## Planning and Zoning Commission Meeting

June 8, 2021

**Date:** May 28, 2021  
**Prepared By:** Jack Hendrix  
**Subject:** Site Plan Review – CPC of Missouri Medical Marijuana Facility

1 NORTH ELEVATION - 01  
A200 1/8" = 1'-0"

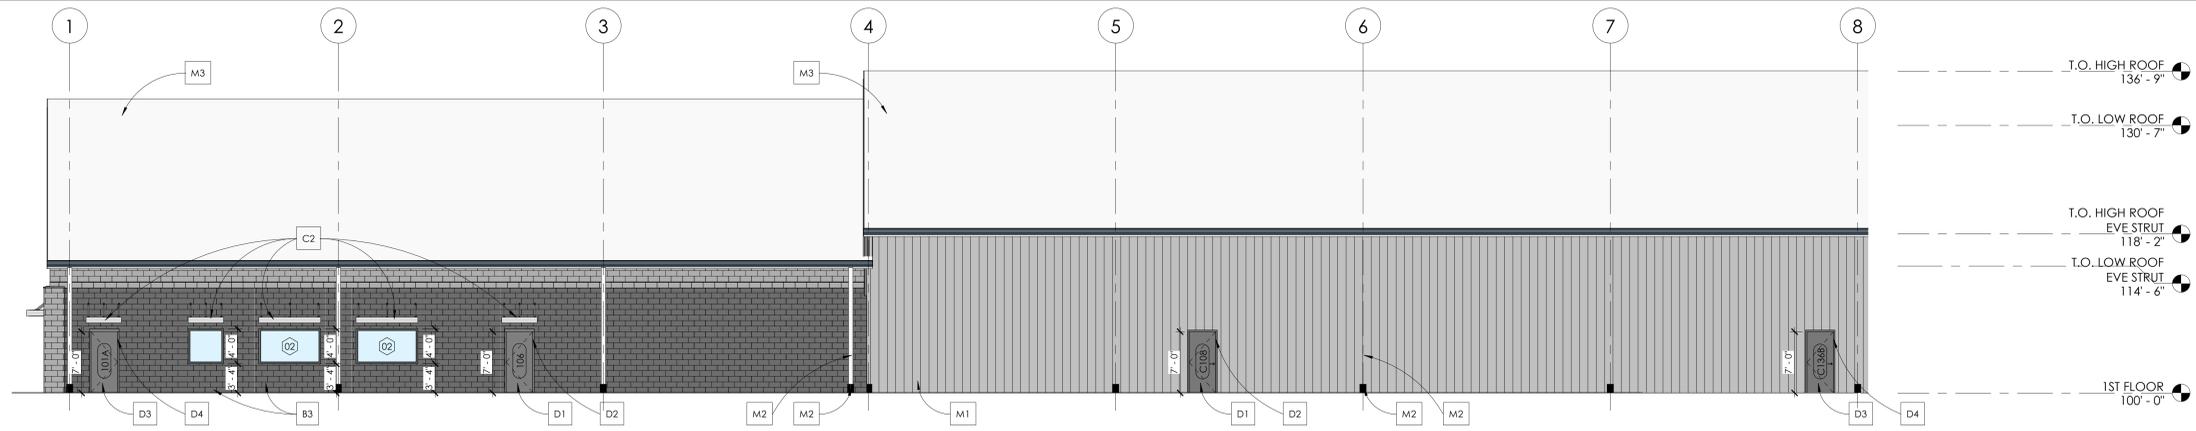
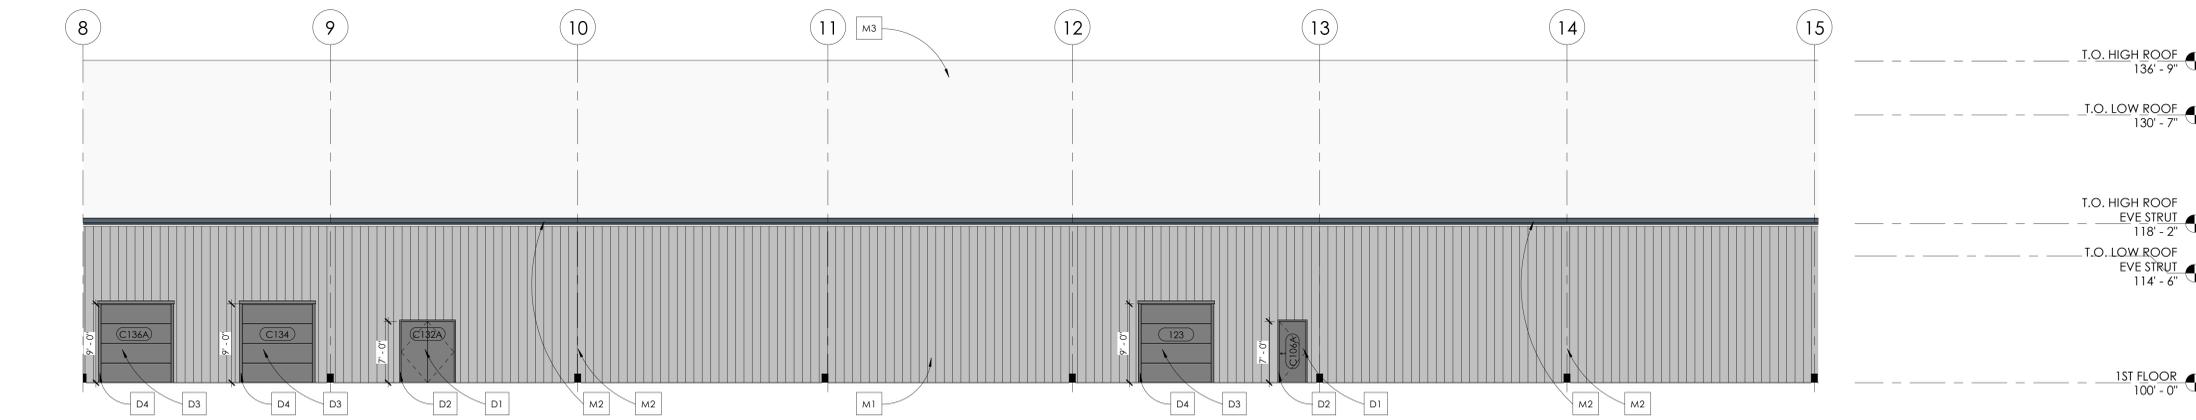
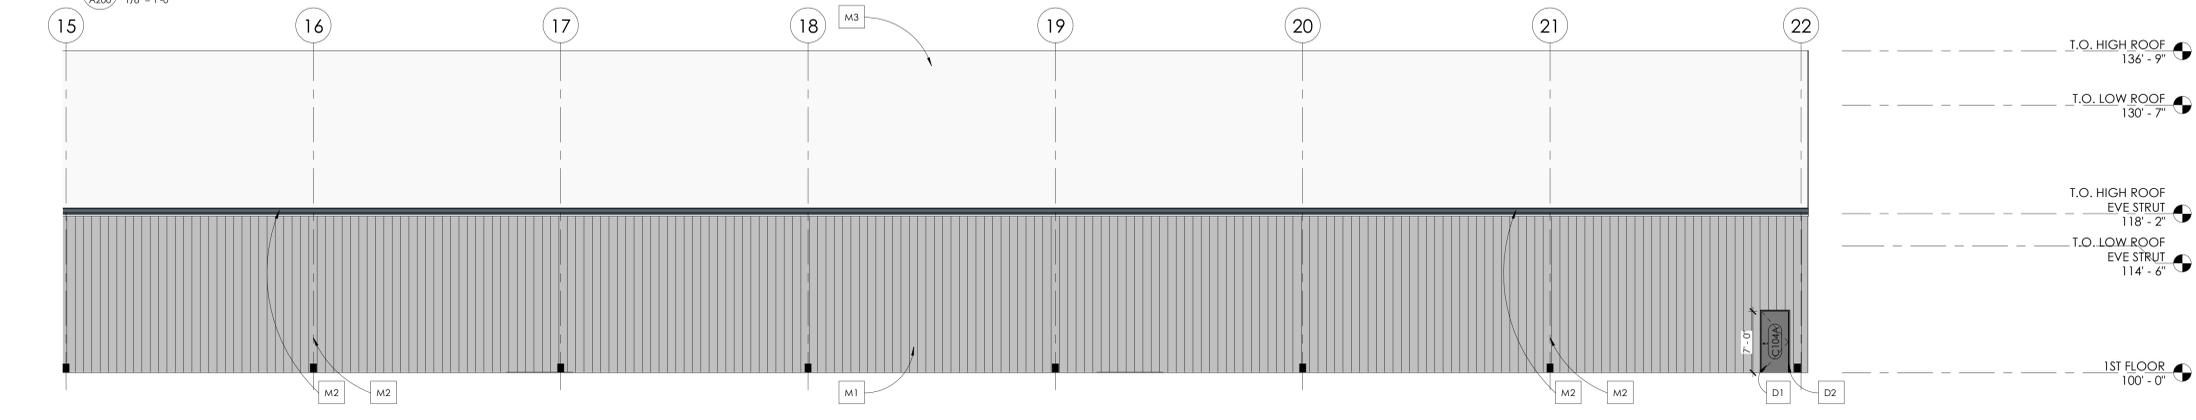
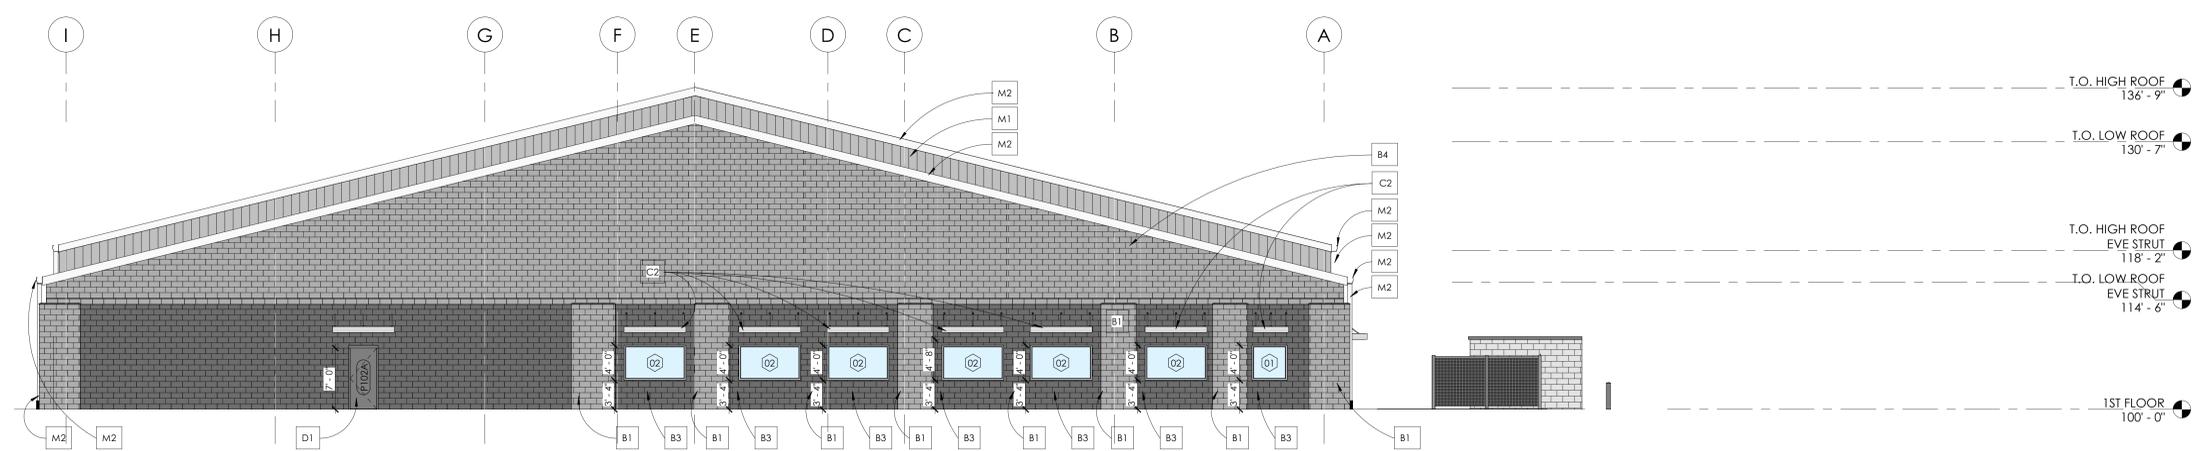
First, the proposed building is substantially larger than any other building we have reviewed (25% larger than Price Chopper's building) and certain design looks called for in the code don't seem to work well with the size of the structure. To stay within the intent of the requirements of the site plan ordinance, staff recommends a few slight variances from the standards. These variances will also be identified herein.

First, the building is exceedingly long, so much that the north and south elevations must be split into three separate drawings. The east and west elevations are contained in one drawing each. The first variance staff recommends adjusting is the roof pitch. Our standards require that the roof be either 3/12 or higher pitched or can be flat roofed. Given the sheer size of the building, a flat roof is not feasible with the proposed

construction method of a steel structured building. That leaves the standard, sloped roof. The proposed building as depicted would need to be over 11' taller at the peak to meet the 3/12 pitch requirements. As stated above, the sheer size of the building makes that height unnecessarily expensive to construct when wind loads are taken into account.

The second variance proposal would be the type and amount of buffering around the number of HVAC units required as a part of the facility. Our standards require exterior ground-mounted equipment shall be screened from view with a solid wall. That section is sufficiently ambiguous that staff recommends that this buffering be present along the side of the units that is visible from the street, and not the full length of the building as well.

This effectively means the ribbed metal panels that are discouraged in the B-3 district are approved in the I-1 district if they meet the gauge and depth requirements as stated. The applicant has submitted plans to meet the I-1 district standards. As a result, staff recommends the Commission approve the design as shown.
